Project	IEEE 802.16 Broadband Wireless Access Working Group < http://ieee802.org/16 >	
Title	Comments on IEEE 802.16j Channel Models in IEEE802.16j-06/013	
Date Submitted	2006-09-19	
Source(s)	<p>Peter Wang, peter.wang@nokia.com Nokia Inc. 6000 Connection Dr Irving, TX 75039, USA.</p> <p>I-Kang Fu, IKFu@itri.org.tw National Chiao Tung University / Industrial Technology Research Institute 1001 Ta Hsueh Road, Hsinchu , Taiwan 300, ROC.</p> <p>Wendy C Wong, wendy.c.wong@intel.com Intel Corporation 2200 Mission College Blvd., Santa Clara, CA 95054, USA.</p> <p>David Chen, david.t.chen@motorola.com Motorola Inc 1441 W. Shure Drive, Arlington Heights, IL 60004 USA.</p> <p>Mike Hart, Mike.Hart@uk.fujitsu.com Sunil Vadgama Fujitsu Laboratories of Europe Ltd. Hayes Park Central Hayes End, Middx., UB4 8FE, UK.</p>	<p>Jun Bae Ahn, jbahn@st.co.kr SOLiD Technologies 10th Fl., IT Venture Tower East Wing, 78 Garak-Dong, Dongpa-Gu, Seoul, 138-803 Korea.</p> <p>Yong Sun, Sun@toshiba-trel.com Khurram Rizvi Dharma Basgeet Toshiba Research Europe Limited 32 Queen Square Bristol BS1 4ND, UK</p> <p>Youn-Tai Lee, lyt@nmi.iii.org.tw Institute for Information Institute 8F., No. 218, Sec. 2, Dun-Hwa S. Rd.,

Figure.4 Type-F NLOS Urban Macro-cell Scenario

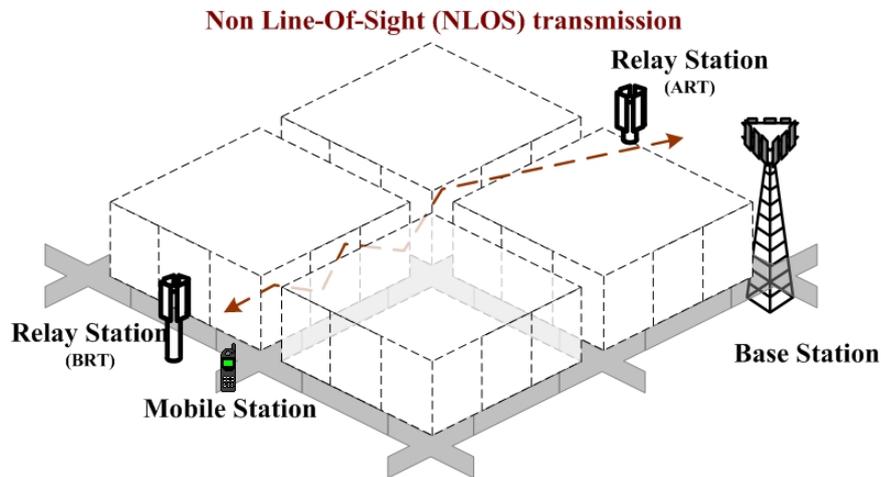
6. Comment on section “2.1.2.5 Type-E:...” in IEEE 802.16j-06_013 document

We propose to change “2.1.2.5 Type-E:...” to “2.1.2.4 Type-F NLOS (ART-BRT) for urban macro-cell scenario”. We adapt WINNER C2 model (urban macro-cell model) and the details are given as following:

2.1.2.4 Type-F: BS-RS, BS-MS, RS-RS, RS-MS, NLOS (ART-BRT) for urban macro-cell scenario

The following path-loss model is considered for Type-F NLOS scenario:

$$Pathloss(d) = 38.4 + 35 \cdot \log_{10}(d) \text{ dB}$$

where d is the distance in meter and $50\text{m} < d < 5\text{km}$.

For this scenario, NLOS transmission is the general case. We may also use 2GHz COST231-Hata model with free-space correction to model path-loss around 5 GHz for Type-F urban macro-cell scenario. When using different carrier frequency, the following frequency correction factor can be added in previous path-loss equation:

$$C(f_c) = 20 \cdot \log_{10}(f_c/5)$$

Note that the results from COST231-Hata model and WINNER C2 measurement are valid between 100m-2000m.

Figure.6 Type-G LOS Scenario

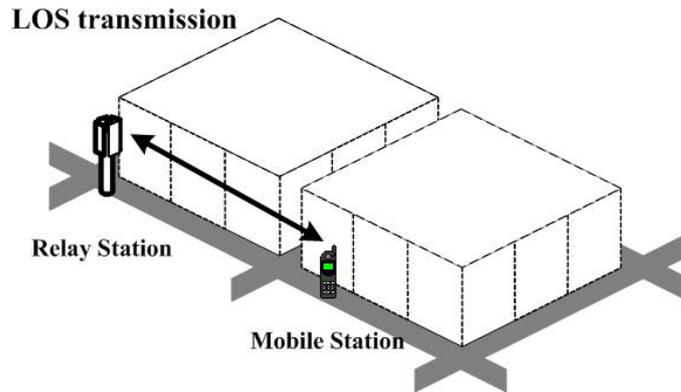
7. Comment on “2.1.2.6 Type-F: RS↔MS, LOS (BRT-to-BRT)” and “2.1.2.7 Type-F: RS ↔ MS, NLOS (BRT-to-BRT) in IEEE 802.16j-06_013 document

We suggest to merge the sections of “2.1.2.6 Type-F: RS↔MS, LOS (BRT-to-BRT)” and “2.1.2.7 Type-F: RS ↔ MS, NLOS (BRT-to-BRT) from IEEE 802.16j-06_013 baseline document together and become one section called “2.1.2.5.Type-G: RS-RS; RS-MS, LOS/NLOS (Urban Micro-cell BRT-to BRT model)”. We suggest using WINNER B1 LOS/NLOS scenario (urban micro-cell model) and removing the Berg’s model due to its high complexity for simulation. The details WINNER B1 model is as following:

For LOS case as in Figure 6:

$$PL(d) = 22.7 \log_{10}(d) + 41.0 \text{ dB} \quad \text{for } 10m < d < 650m$$
